Proposed Upstream Fishway Final Design Plans submitted to FERC

Submission for the Shawmut Hydroelectric Project (FERC No. 2322) Upstream Fish Passage Facility

SHAWMUT HYDROELECTRIC STATION UPSTREAM FISH PASSAGE

PROJECT: 3173SHAWFISH
DRAWN BY: M. PITTMAN
DESIGNED BY: D. ROBINSON
APPROVED BY: M. GRAESER
SHEET: 14 OF 176
DRAWING: C-104

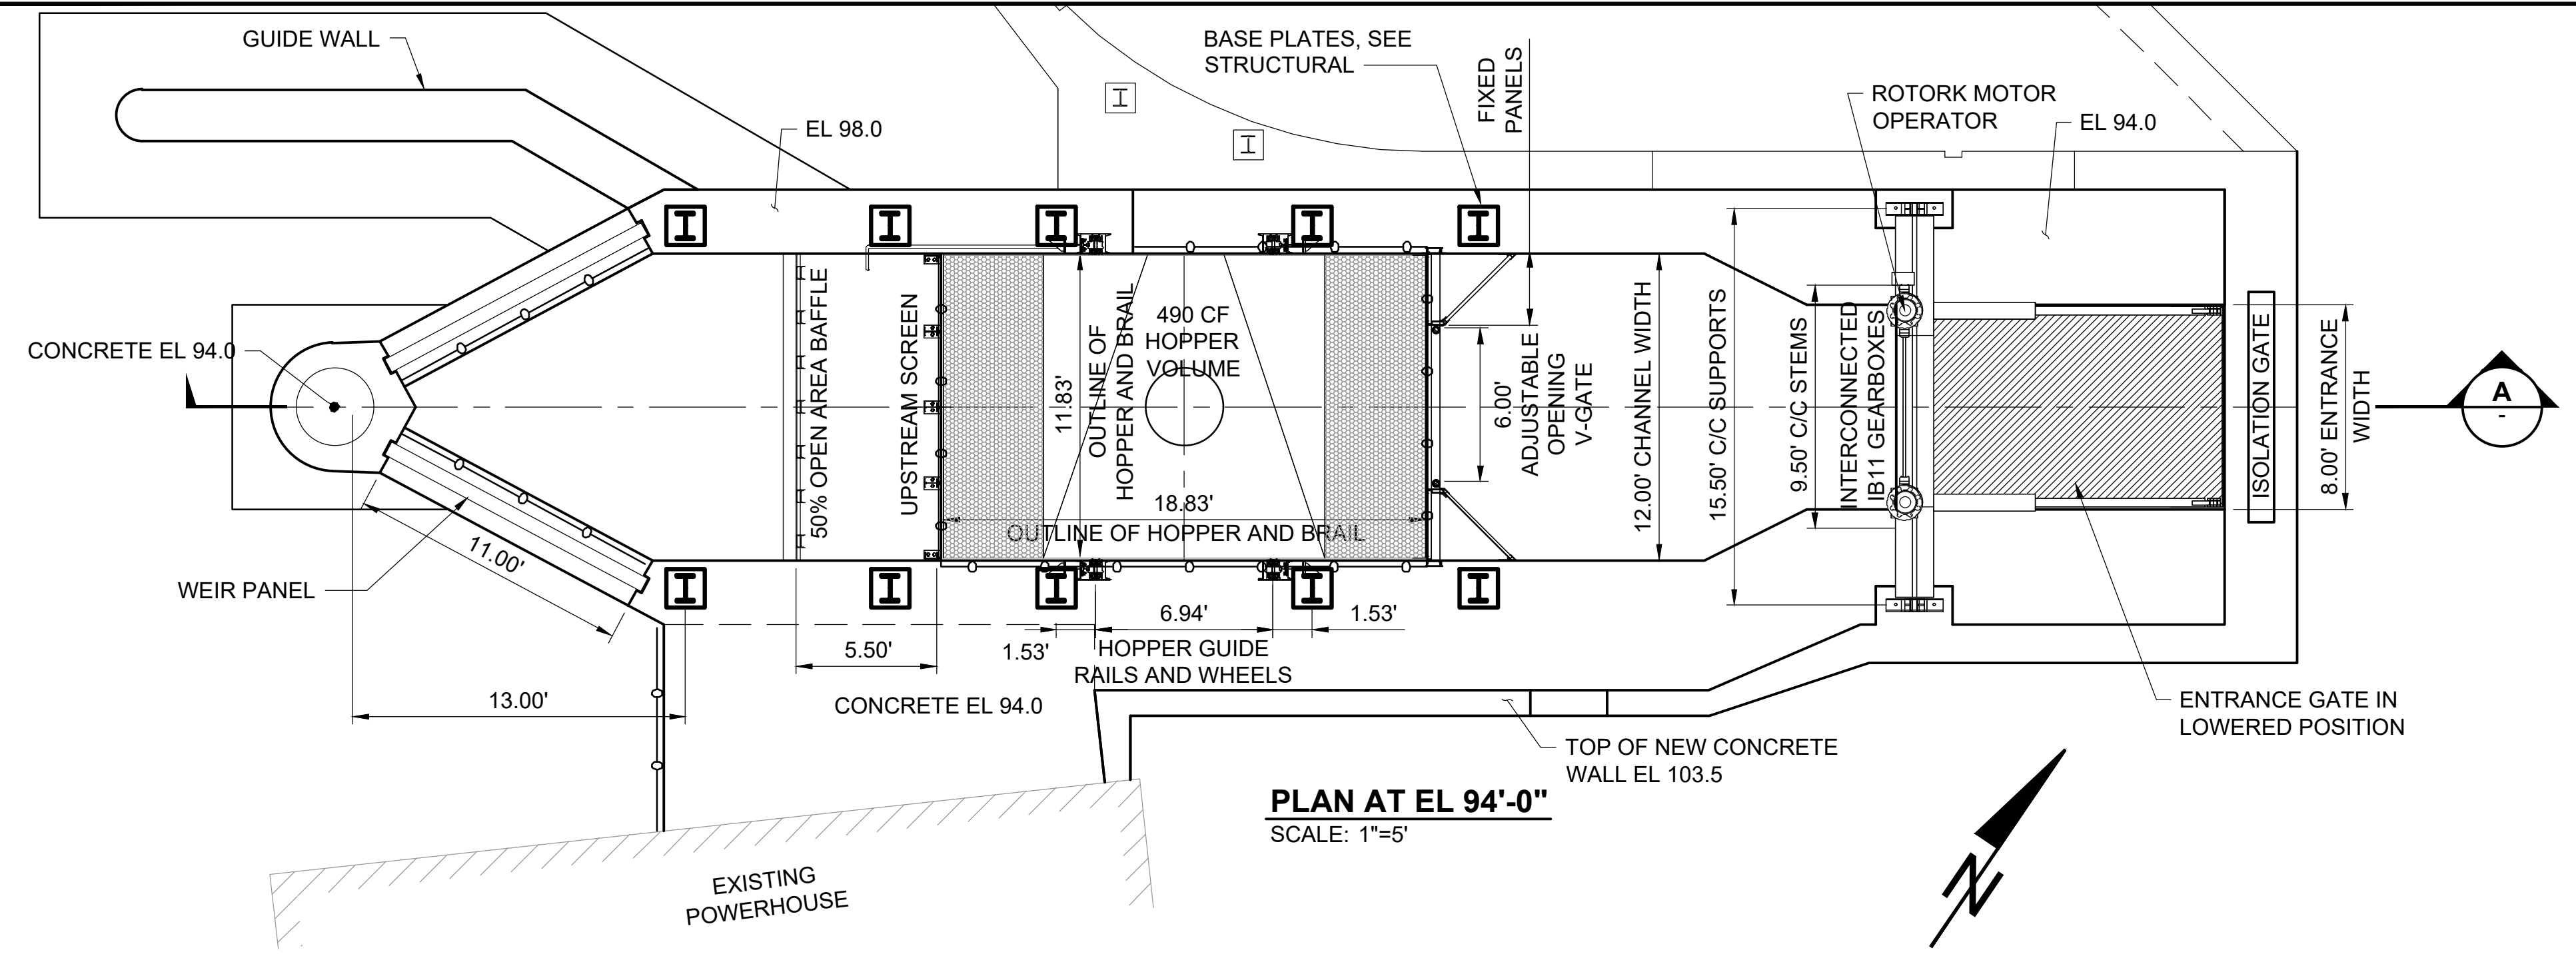
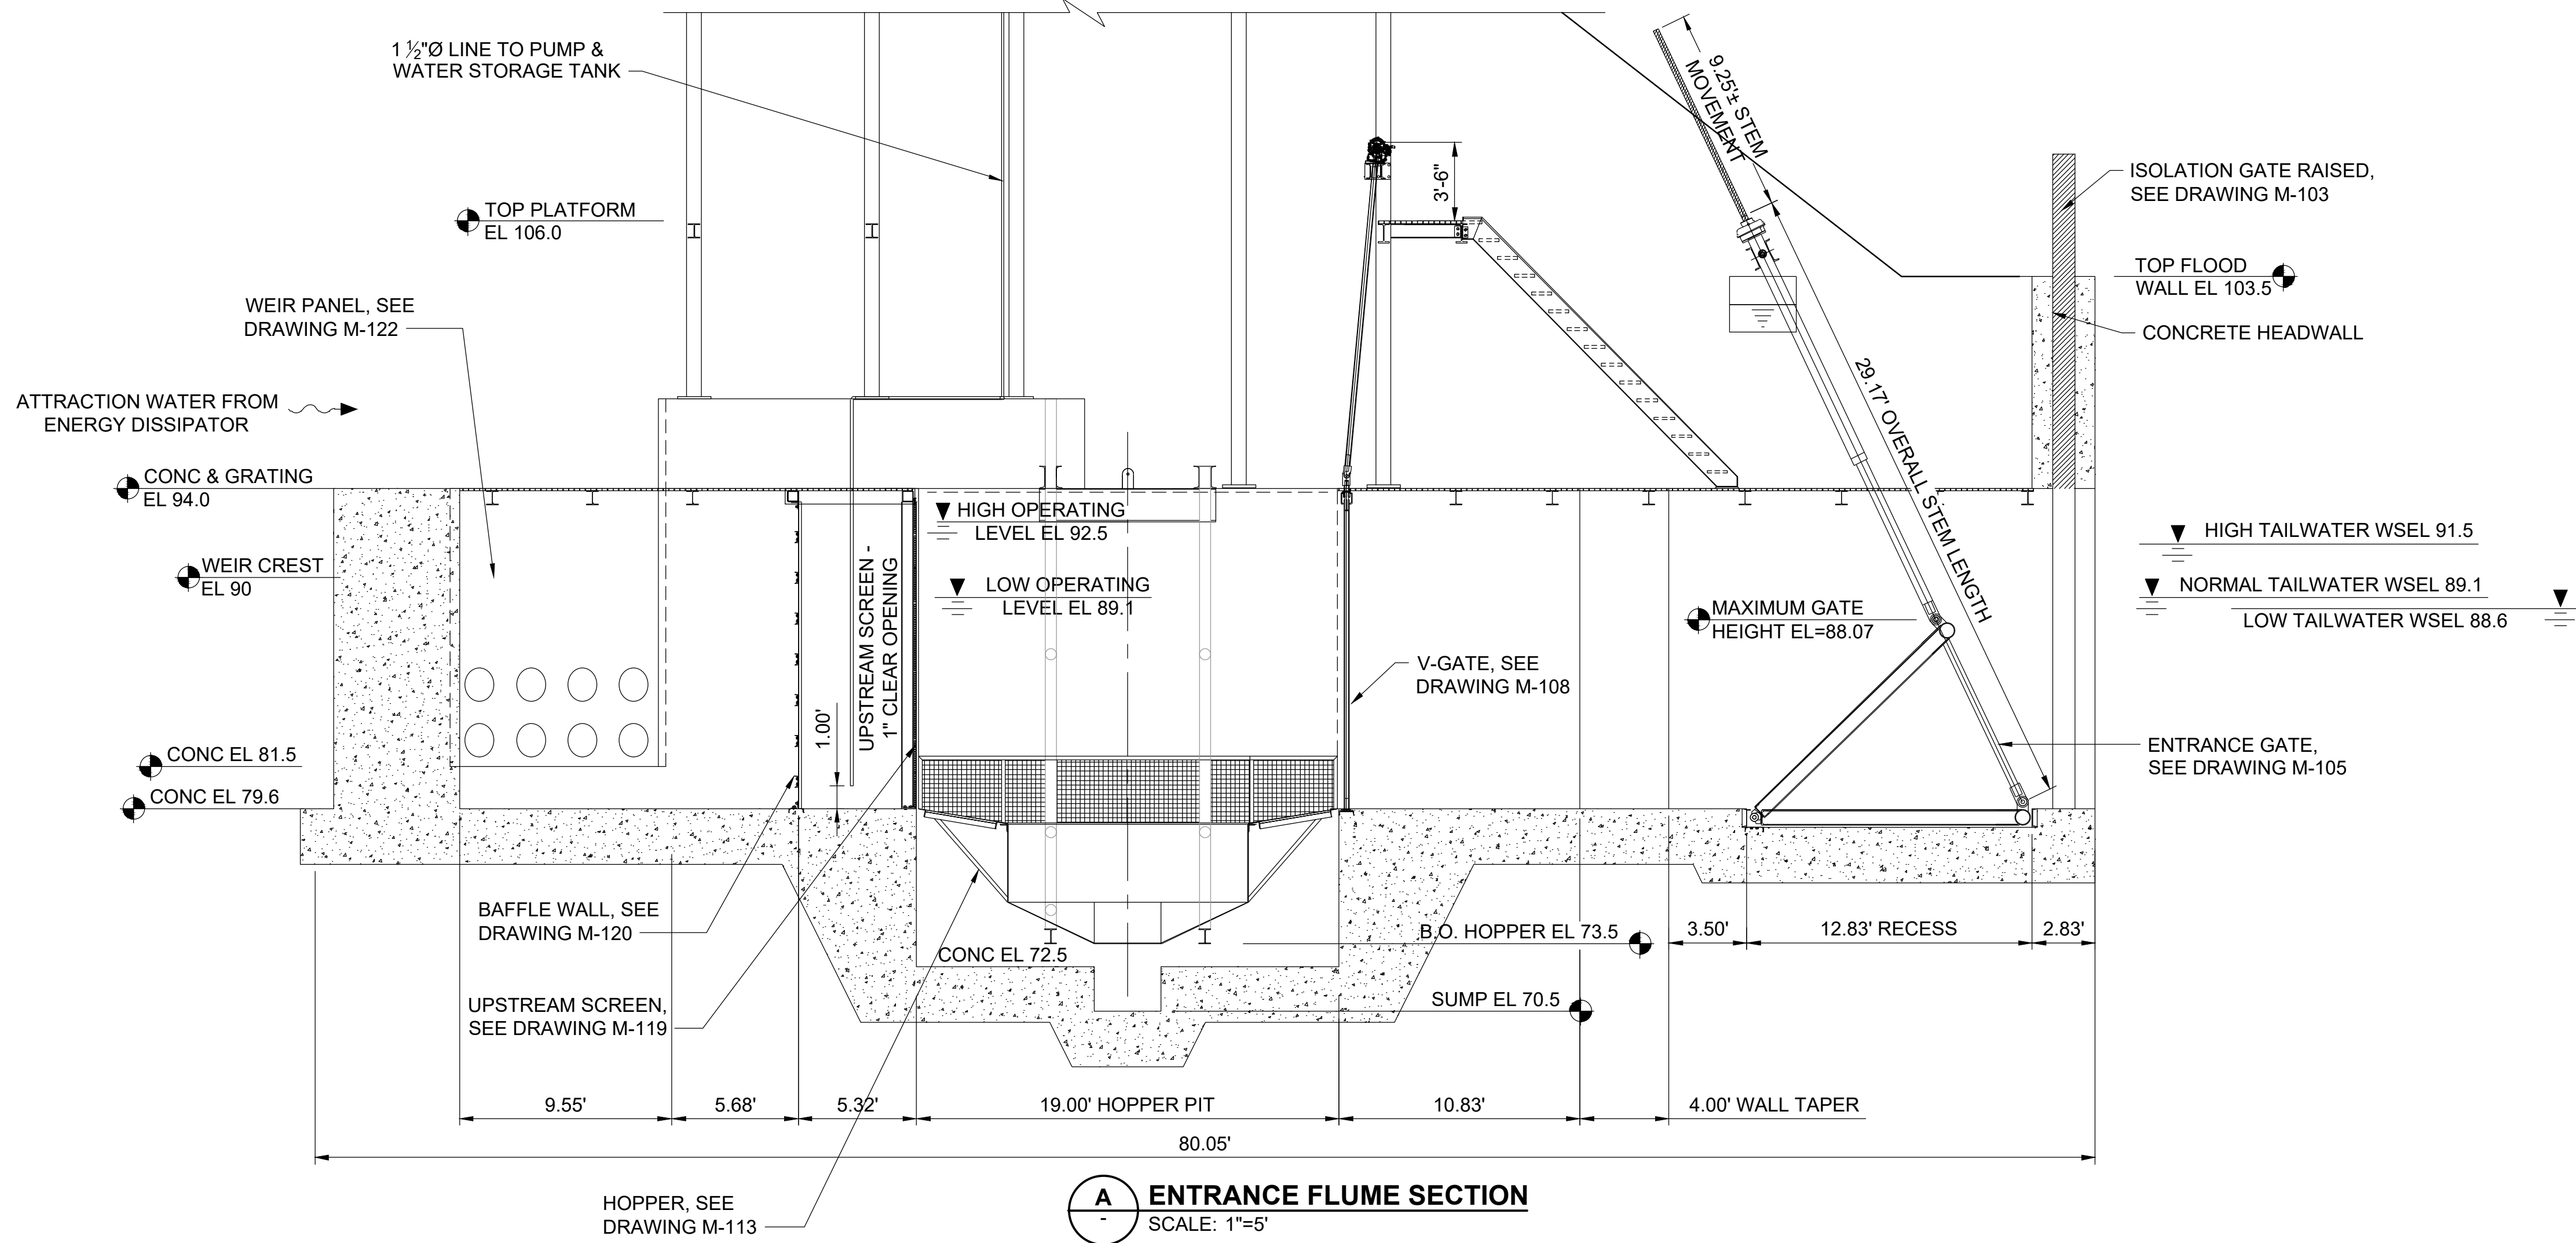
Sheet C-104: The dimension of the entrance width shows 10.0 ft. This dimension should be 8.0 ft.

4. DWG C-104 Note 1 - did not show depth

We also caught that one on Sheet C-104 and it has been corrected in our latest set issued for bid. See attached for reference.
